**Reference:** Re. Compliance with Condition no. 3 of Final Grant Permission SD21A/0171

PROJECT:  
SAGGART RESERVOIR  
DESIGN AND BUILT CONTRACT

TITLE:  
PAUL HURLEY FIELD  
PLAN LAYOUT

DRAWING NO.:  
J1387-PH-001

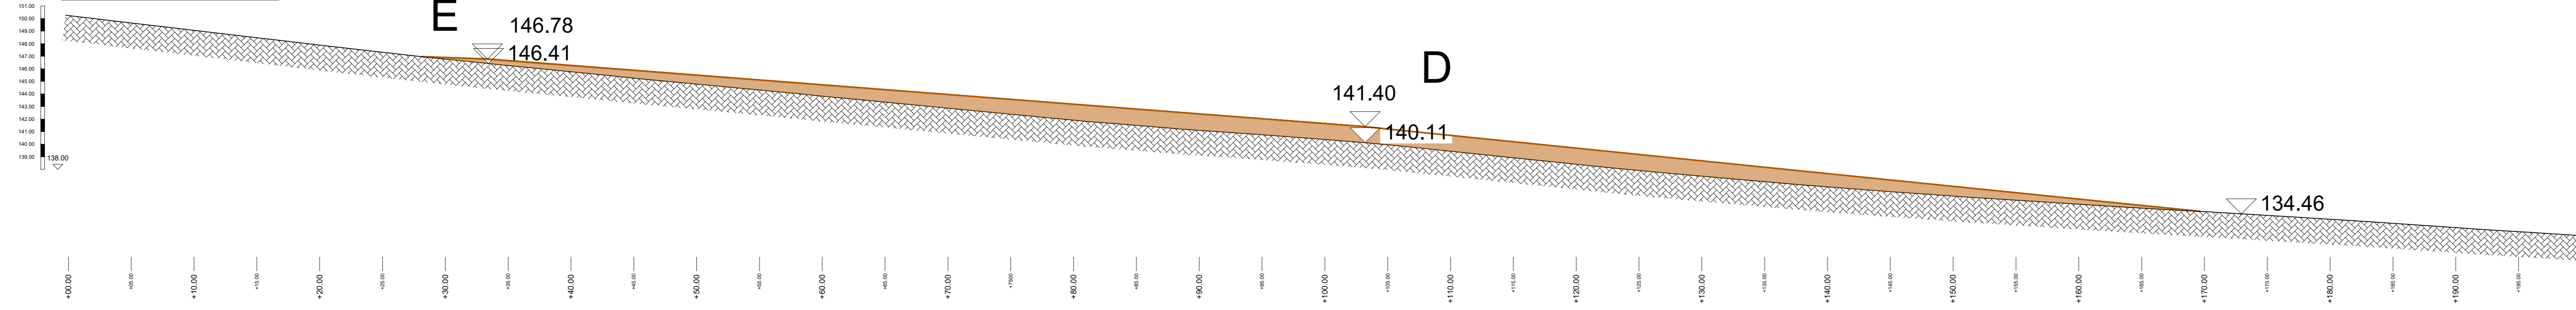
*The applicant shall submit a revised report showing the proposed infill will not be on the flood zone as shown on the relevant CFRAM OPW map. A revised note will also be submitted showing any change to the infill area will not affect slope stability. Also a drawing will be submitted showing a protective route of fencing erected to demarcate a 10m buffer strip for boundary hedgerows and the flood zone where that area is outside the aforementioned 10m buffer strip.*

Attached Drawing J1387-PH-001 has been updated to remove infill from the CFRAM OPW map. The volume, slope or depth of infill has not changed therefore the changes are not believed to affect stability. Attached updated Drawing J1387-PH-001 also shows a protective route of fencing erected to demarcate a 10m buffer strip for boundary hedgerows and the flood zone. Silt fencing is also shown 10m from the flood zones and River Camac.
